PRODUCT CHANGE NOTICE

1. TITLE IRHM7264SE (JANSR2N7434) SOA Change		2. DOCUMENT NUMBER FV5-C-14-0013
		3. DATE August 12, 2014
4. MANUFACTURER AND ADDRESS International Rectifier 205 Crawford Street Leominster, MA 01453		5. MANUFACTURER PART NUMBER See below for IR Part Numbers
		6. BASE PART NA
		7. NATIONAL STOCK NUMBER (NSN) NA
8. CAGE 69210	9. EFFECTIVE DATE August 12, 2014	10. GOVERNMENT NUMBER NA
11. POINT OF CONTACT Manufacturer's Representative or Customer Service Representative (978) 534-5776		12. DRAWING NUMBER NA
		13. SPECIFICATION NUMBER MIL-PRF-19500

New IRHM7264SE SOA Curve:

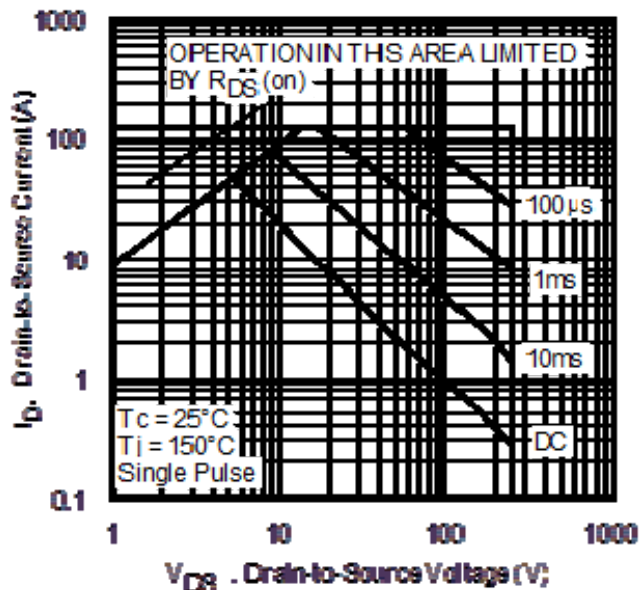
SOA specification at 80% of V_{DS} , and 10mS from: $I_{AS} = 1.6A$ to: $I_{AS} = 2.04A$
